COMMUNICATIONS EQUIPMENT MODIFICATION NO. 14

SUBJECT : Installation of Antenna Transfer Assembly Switch.

EQUIPMENT AFFECTED : B222 Transmitter, Dual 1.23KW, NWR

SUBJECT: Transmittal Memorandum for Engineering Handbook No. 7, Issuance 84-5

Figure 1

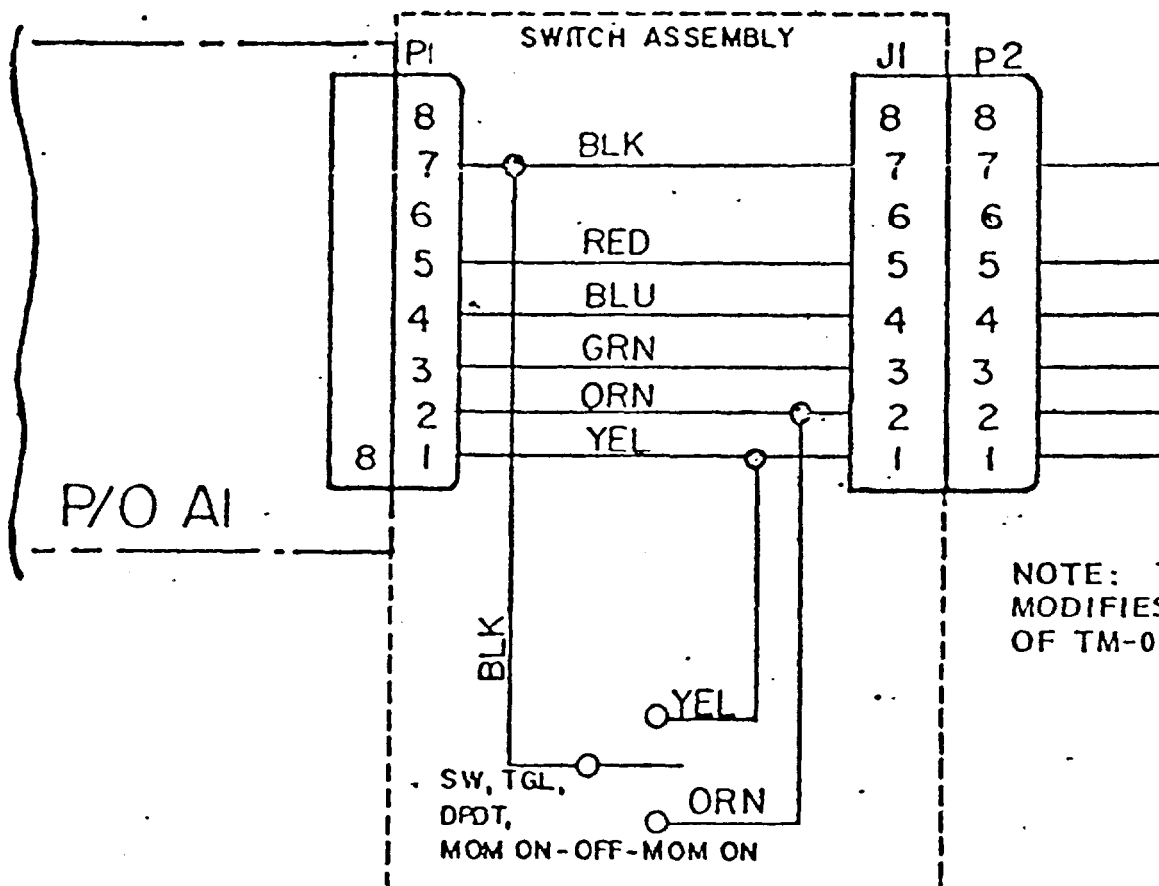
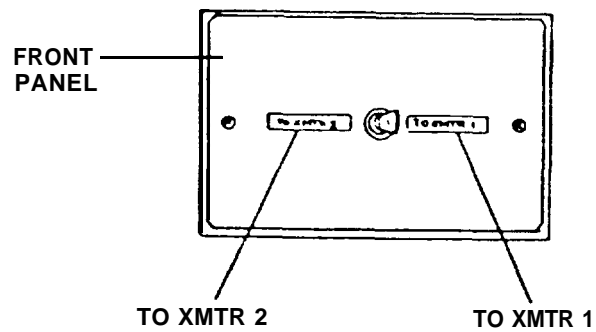
1. Remove the antenna transfer box front cover using Phillips screwdriver.
2. Unplug P2 from switching PC Board A1.
3. Plug J1 of the switch assembly into P2, and P1 of the switch assembly into PC Board A1. (See Figure 1.)
4. Check switch operation as described below:

NOTE: Make necessary pen-and-ink changes to Figure 15-1 of Page 15-3 of Manual TM 0416D. per Figure 1 of this modification.

NOTE: THIS DRAWING
MODIFIES FIGURE 15-1
OF TM-0416D

Figure 2

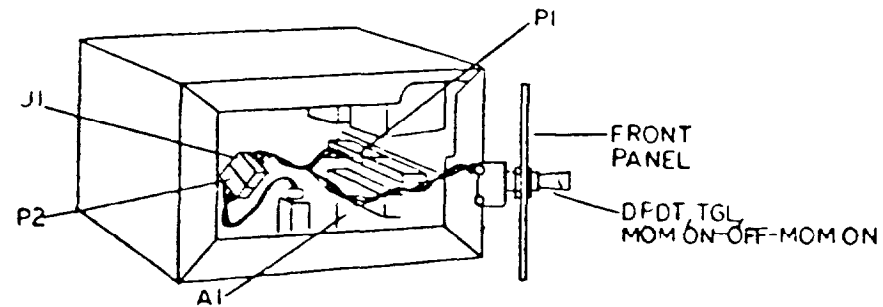
5. Install new transfer box front panel. (See Figure 2.)
